# WARRANTY BULLETIN

Campaign no.: 2014-0007

Subject: **Loose Windshield on RT Models**

No. **2014-6**

### SLEEVE LOCATION

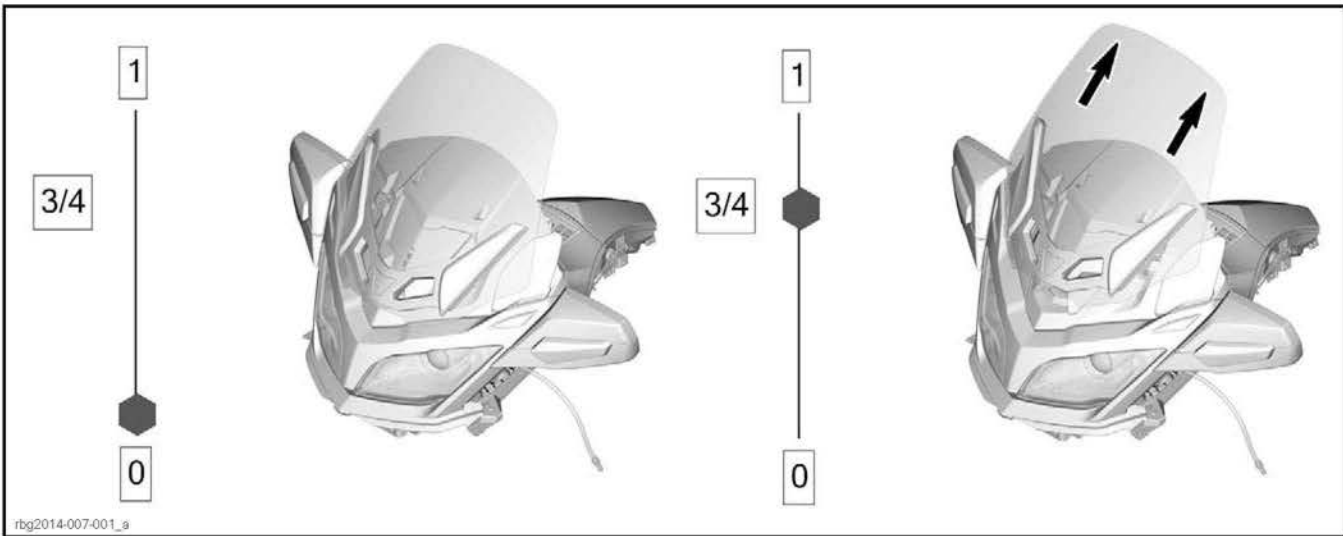
One or more of the screws holding the windshield assembly may break.

Removing all three sleeves and screws at once will result in the windshield assembly falling onto the vehicle.

Replace the windshield assembly sleeves and screws. Refer to *PROCEDURE* in this bulletin.

1. 21 mm (13/16 in)
2. 61 mm (2-3/8 ft)

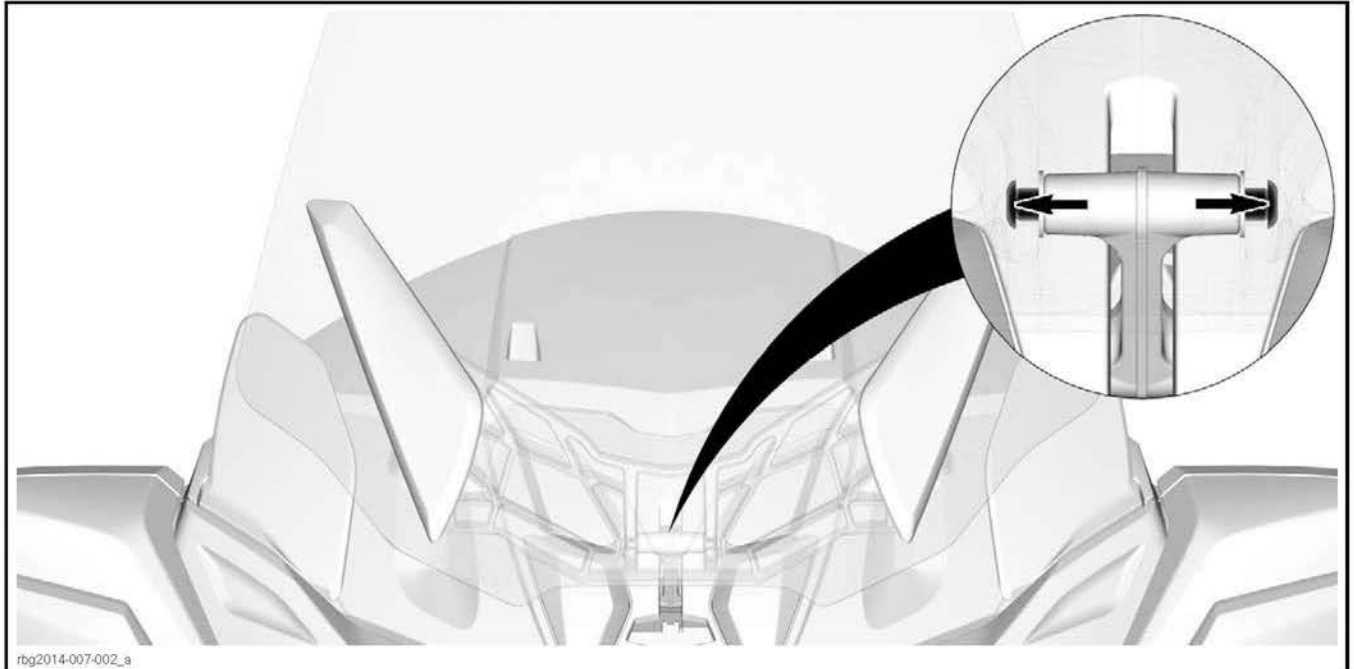
1. Raise the windshield to 3/4.

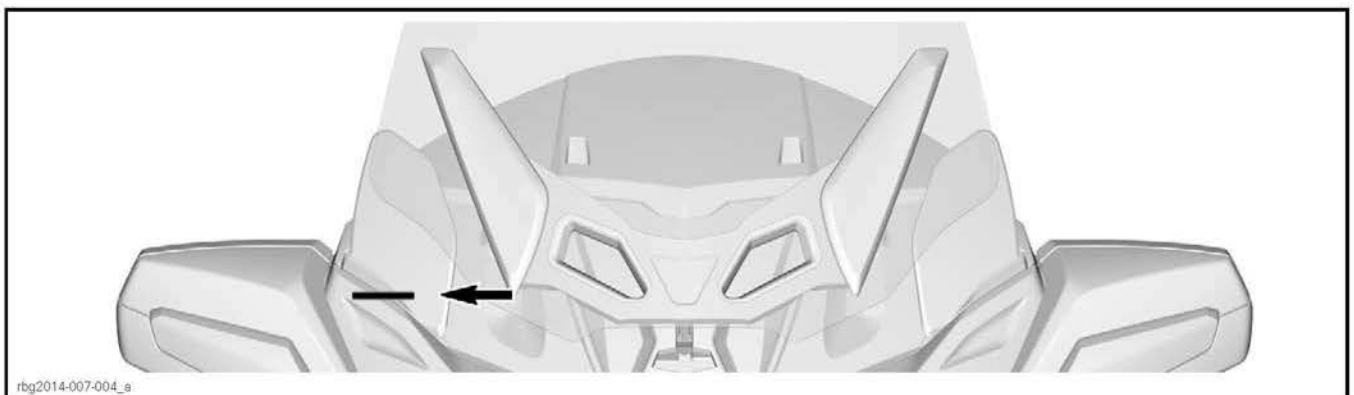
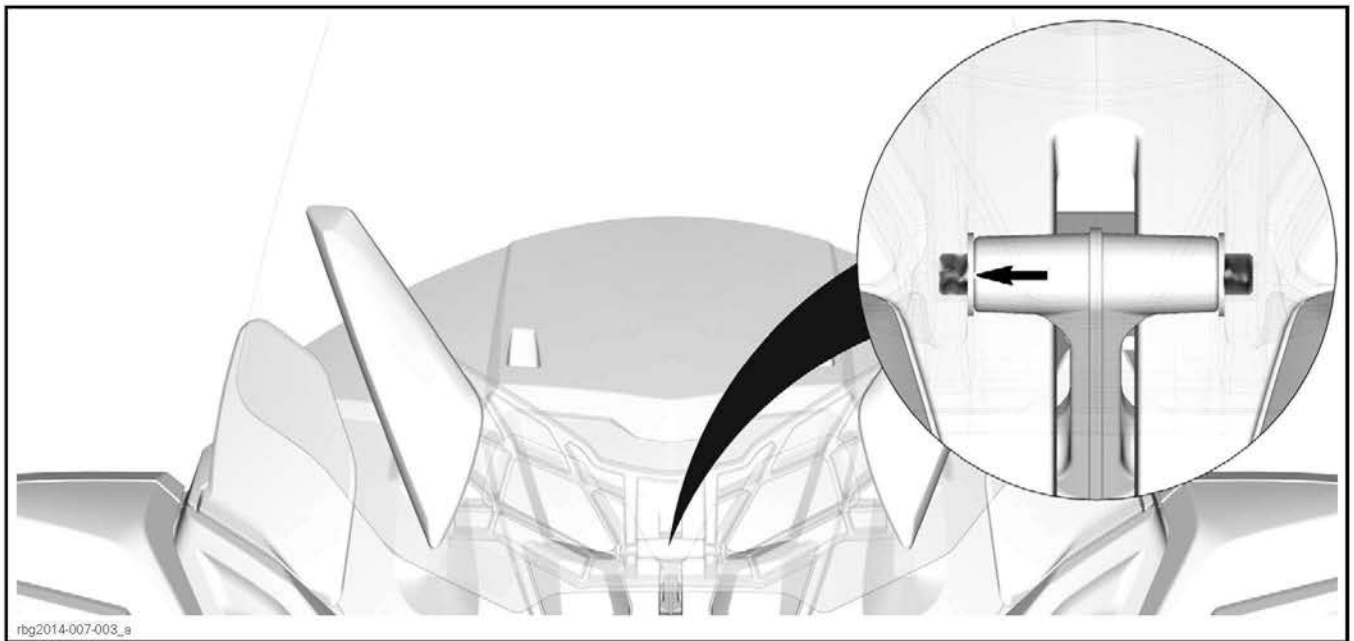
2. Remove screws.

3. Remove sleeve.

4. Discard the old sleeve and screws.
5. Install appropriate sleeve and screws from the *REQUIRED PARTS*.

TIGHTENING TORQUE	
Screws	4.5 N•m ± 0.5 N•m (40 lbf•in ± 4 lbf•in)
